Art Unit 2627
Serial No.: 10/816,158

Reply to Office Action of: 10/03/2006
Attorney Docket No.: K35R1875

AMENDMENTS TO THE DRAWINGS

ANNOTATED SHEET SHOWING CHANGES

FIG. 1

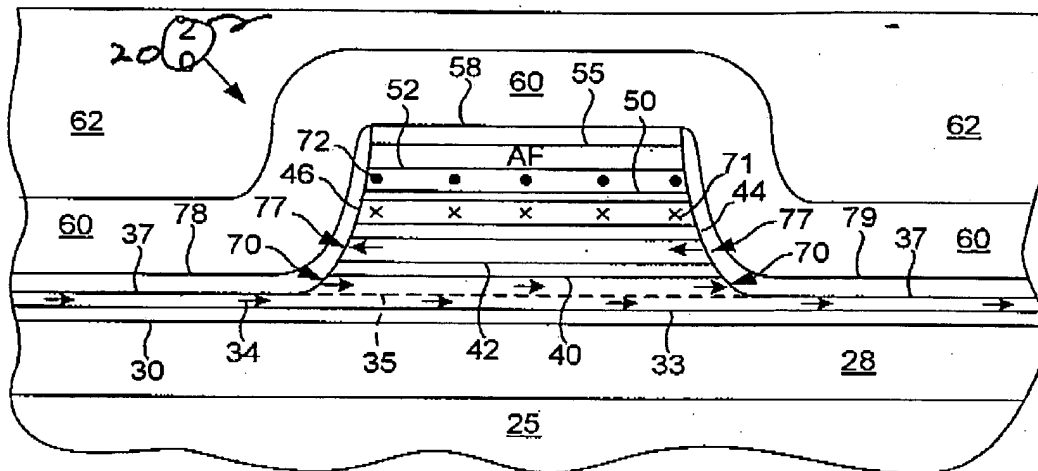
The attached sheets of drawings include changes to Figs. 1-5 and 7-10 and a new Fig. 11. Fig. 11 illustrates a feature of second layer 355 of the ferromagnetic pinning structure 350 that was claimed in Claim 11 and described in the specification at paragraph [0050] of the specification as originally filed. The remaining changes, shown in corresponding annotated sheets, make corrections to the reference numerals. Reference numerals extending over multiple lines of text have been amended to lie on the same horizontal line. Reference numerals not used to refer to the corresponding to the elements described in the text have been corrected either by correcting the numeral or repositioning the line connecting the reference numeral to the associated element. Lastly, reference numerals not used in the description as amended have been removed. No new matter has been added by any of these amendments.

Applicant has addressed the Examiner's objections with respect to the reference numerals as follows. The specification has been amended to include references to the drawing elements identified by reference numerals 162, 245, 251, 280, and 382. Regarding reference numerals 162, 245 and 280, the reference numerals were inadvertently omitted from the description; appropriate correction has been made. Regarding reference numeral 251, the description of the identified element, which corresponds to element 351 of Fig. 9 (see paragraph [0048] of the specification as originally filed), was inadvertently omitted. This omission has been corrected. Reference numeral 382 was also inadvertently omitted from the description in addition to being drawn to the wrong set of dots in the drawings. Both errors have been corrected. Reference numerals 290, 370, 377, and 390 were unused in the description, and they have been removed from the drawings, along with the instances of reference numerals 430 and 472 drawn to the wrong elements. The drawings have also been amended to have reference numeral 278 in Fig. 8 drawn to the correct element and to correct the inadvertent use of "178" in place of "478" in Fig. 10.
